Access Compliance Report

Public Rights-of-Way

(Curb Ramps)

Intersection ID: 3625	Main Street: SANDRINGHAM_PL	Cross Street: CHOWNING_TAVERN_LN	Location: W
ADA ID: 34BE8EAC1607	Ramp Type: Perp	Initial Pass/Fail: Fail	Overall Compliance: No
Codes/Mitigation Info/Possible Solution		Field Measurements/Component Compliance	
Severity Score: 33.75

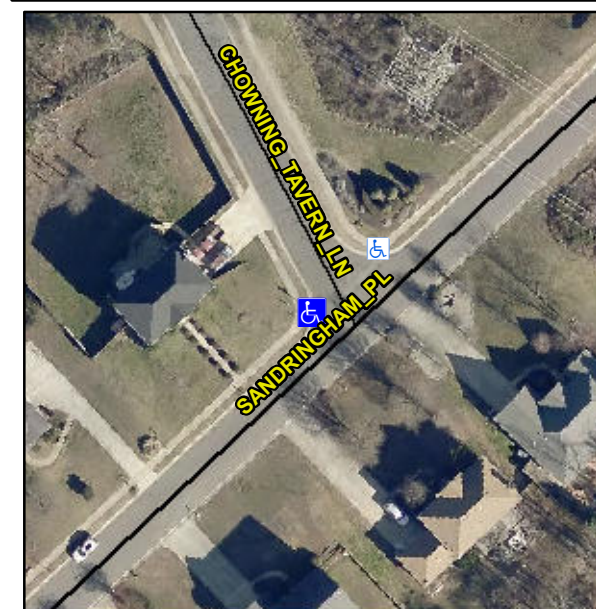
Not Found, R304.5.1, R304.5.3

Compliance	Description	Data	Compliance	Description	Data
N/A	Ramp Length (in)	47.0	Yes	Ramp Slope (%)	5.0
No	Ramp Width (in)	43.5	No	Ramp XSlope (%)	11.1
N/A	Flare Type LT	N/A	N/A	Flare Type RT	N/A
N/A	Flare Slope LT (%)	N/A	N/A	Flare Slope RT (%)	N/A
N/A	Flare Traversable LT?	N/A	N/A	Flare Traversable RT?	N/A
N/A	Landing Length (in)	N/A	N/A	DWS Provided?	N/A
N/A	Landing Width (in)	N/A	N/A	DWS Contrast?	N/A
N/A	Landing Slope (%)	N/A	N/A	DWS Length (in)	N/A
N/A	Landing X Slope (%)	N/A	N/A	DWS Full Width?	N/A
N/A	Landing Curb? (Y/N)	N/A	N/A	DWS Offset (in)	N/A
N/A	Shared Landing?	N/A			
N/A	Gutter Ponding?	N/A	N/A	Gutter Slope (%)	N/A
N/A	Gutter Lip Ht (in)	N/A	N/A	Gutter X Slope (%)	N/A
N/A	Painted X Walk1?	No	N/A	Painted X Walk2?	N/A
	X Walk 1 Direction	To NE		X Walk 2 Direction	N/A
N/A	X Walk 1 Width (in)	N/A	N/A	X Walk 2 Width (in)	N/A
	X Walk 1 Slope (%)	5.0		X Walk 2 Slope (%)	N/A
	X Walk 1 X Slope (%)	9.6		X Walk 2 X Slope (%)	N/A

N/A	Ramp inside XWalk1?	N/A	N/A	Ramp inside XWalk2?	N/A
	Road Slope (%)	N/A	N/A	Clear Space?	N/A
	Road X Slope (%)	N/A	N/A	Clear Space to XWalk (in)	N/A
N/A	Any Obstructions?	N/A	N/A	Storm Grate/Utility Hazard?	N/A
	Obstruction Type			Storm Grate/Utility Type	
		N/A			N/A
			Yes	Surface Condition? (G/P)	Good

Remove & Replace Entire Ramp.
